~1234 Lincoln Street
Bellingham, WA

**Cushing
Terrell**

Maximum 200 Studio Units
175 Parking Stalls (8'10"x15' typical)
NFA13 Fully Sprinklered

PLAN

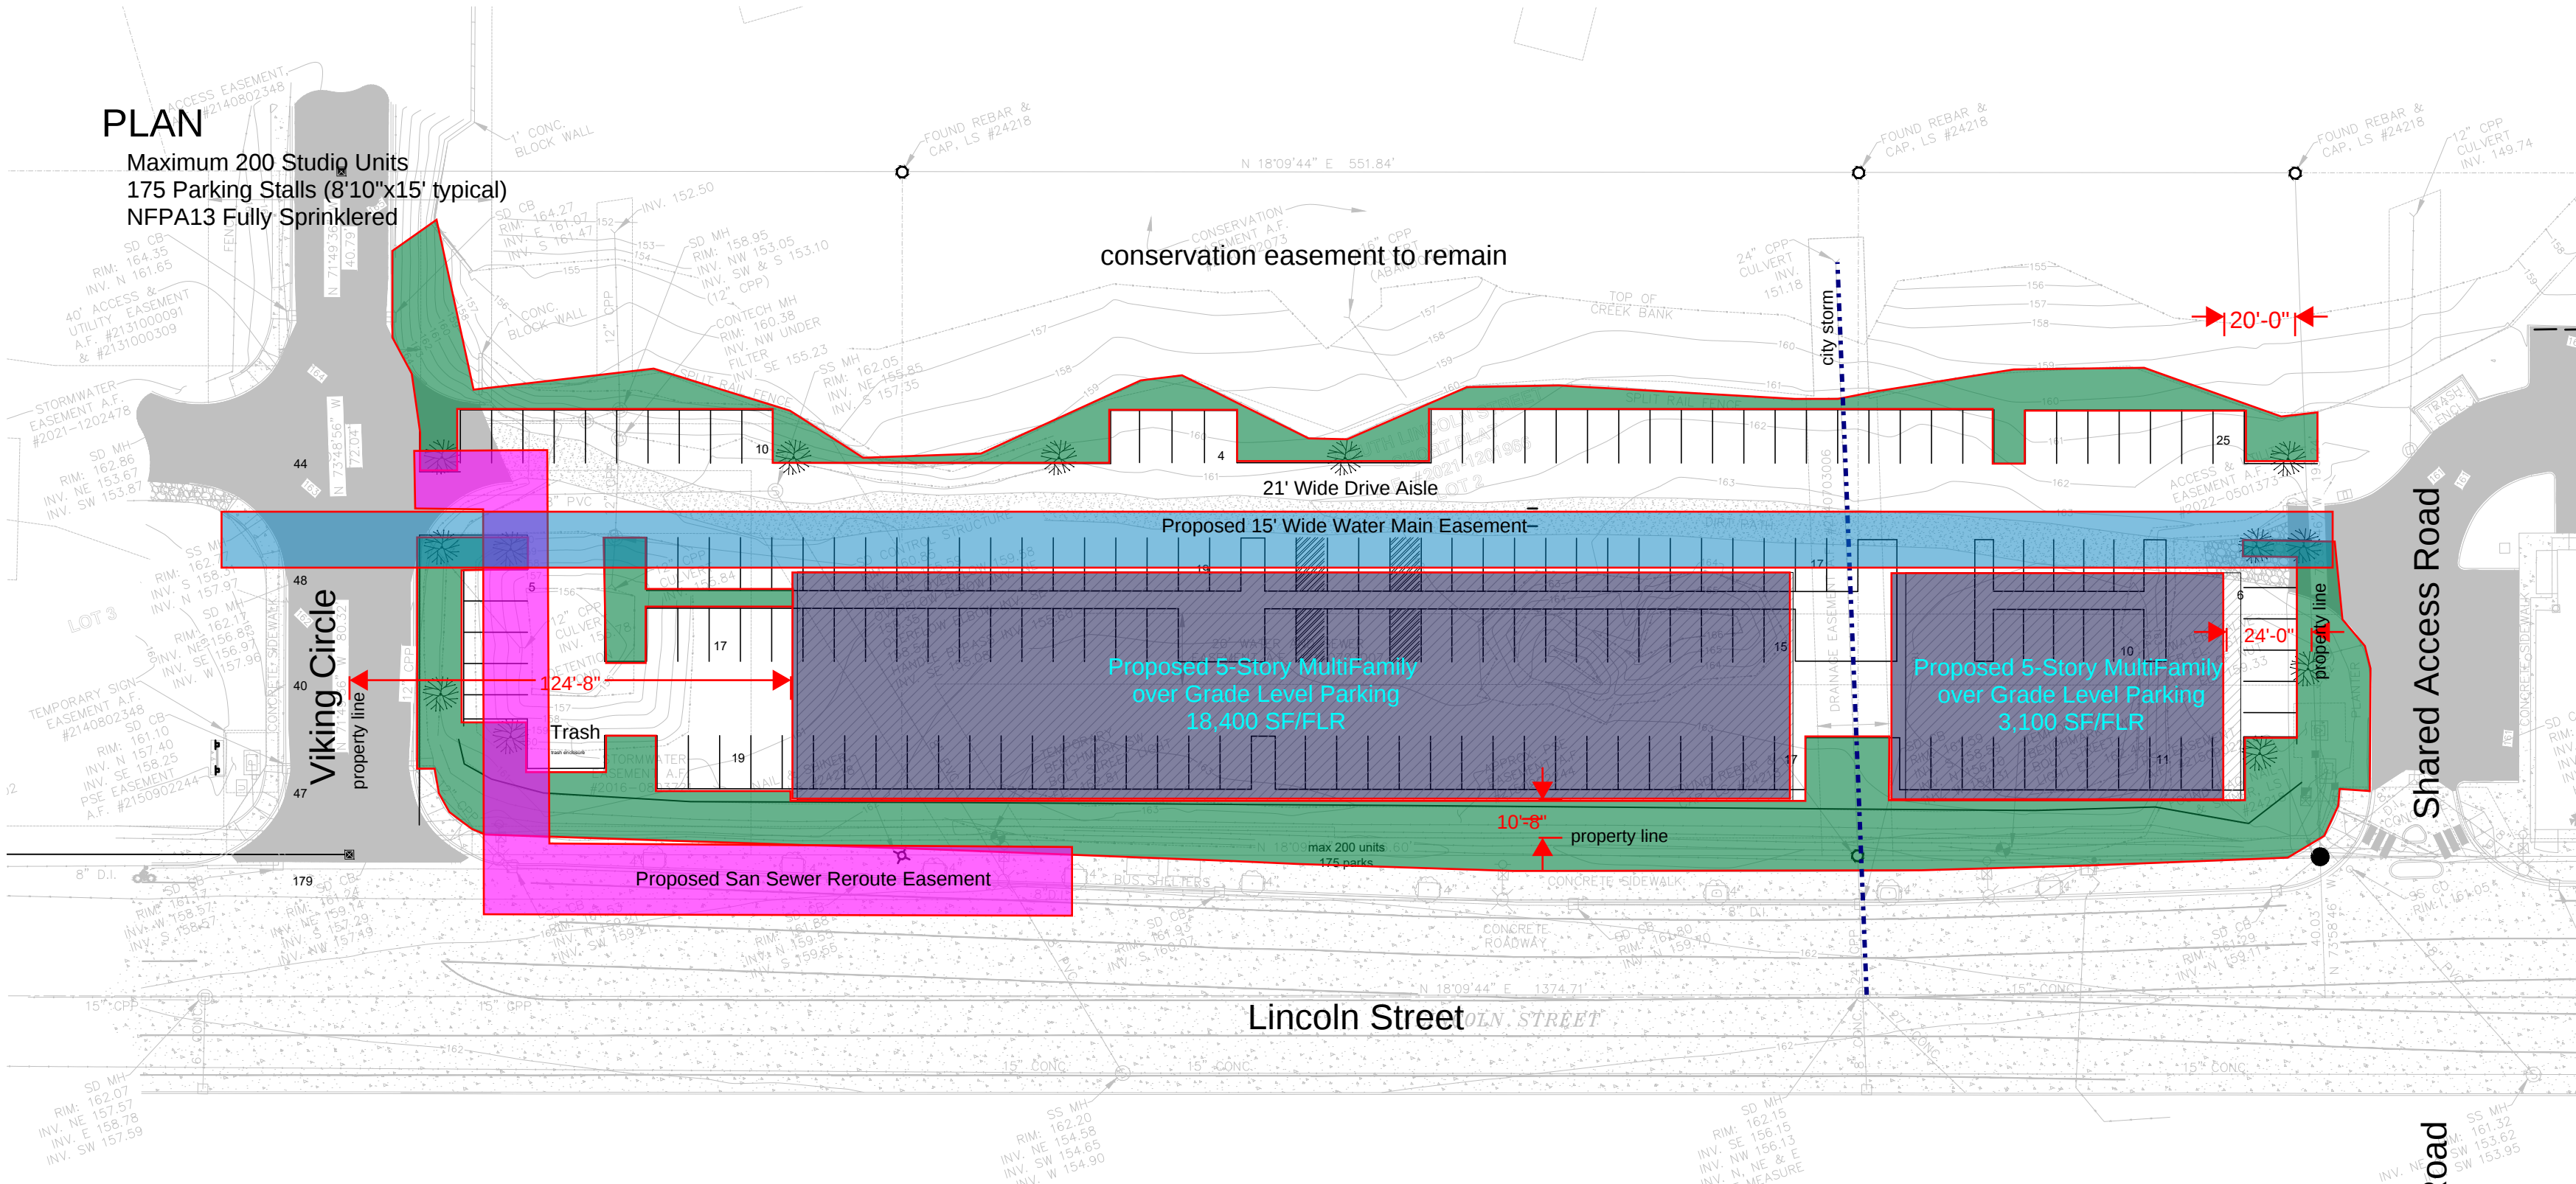
- Primary Questions for Consideration :
1. City Storm currently passes transversely from East to West through the Site and discharges into the conservation creek. We propose separating the building here but keeping it connected at floors four and five (and possibly third floor as well). Is there a minimum clear height above the easement preferred/required by the City for maintenance?

2. Confirmation that the proposed sanitary sewer reroute would be amenable to the City.
 3. We are proposing a 15' wide water main easement through the property (eliminating the current longitudinal water easement). This will allow more surface for permeable paving and storm remediation on site and still keep the water main accessible for maintenance.

4. The rear drive aisle is 21' wide and in compliance with parking regulations. It is our understanding that this aisle would not be conducive to fire fighting apparatus due to its close proximity to the building, and thus will not require fire truck width for maneuvering purposes.

5. Trash pickup location is head-in and on the left (south) side of the proposed building location.
